Application Reference: A007121388
Address of Site: 154 BEAMS RD ZILLMERE QLD 4034

RE: Information request in accordance with the Development Assessment Rules

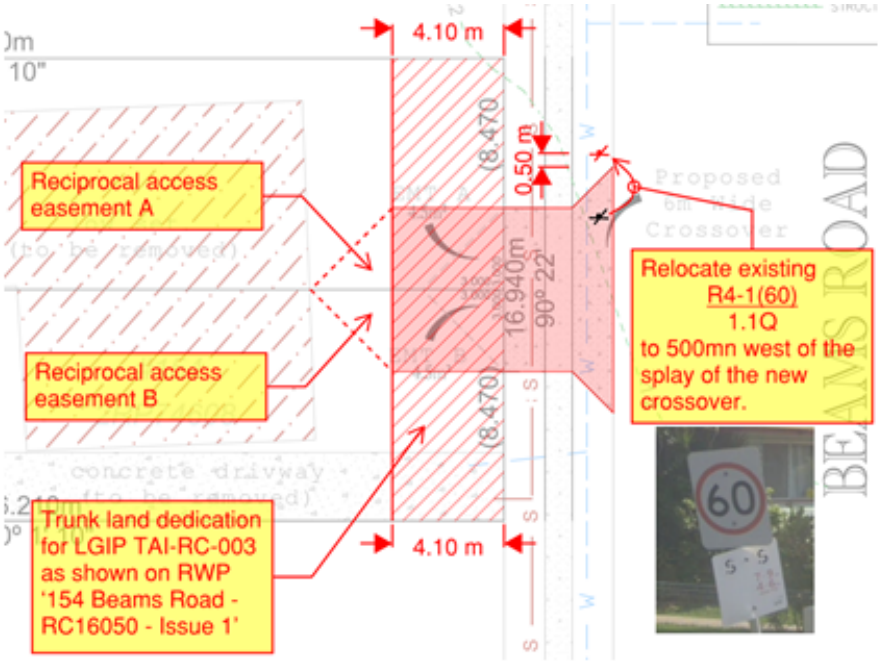
1. The proposed plans do not demonstrate compliance with IDPSP Transport, access, parking and servicing code (9.4.11). A trunk land dedication is required from this site as shown on road widening plan 154 Beams Road - RC16050 - Issue 1.

a) Provide a RPEQ prepared concept plan demonstrating trunk land dedication were driveway needs to be extended 4.1m beyond the boundary and a reciprocal access easements extending to a depth of 3m as per drawing below.

i) In accordance with the PO5 with the road hierarchy code, provide a 4.1m wide trunk dedication along the full length of the Beams Road frontage, as per LGIP item TAI-RC-003.
        ii) Demonstrate the relocation of the existing 60 km/h speed limit sign and parking control sign 500mm to the west of the new driveway crossover as per the drawing below.
        iii) Provide revised plans showing trunk dedication area and adjusted crossover arrangement as per below mark up:
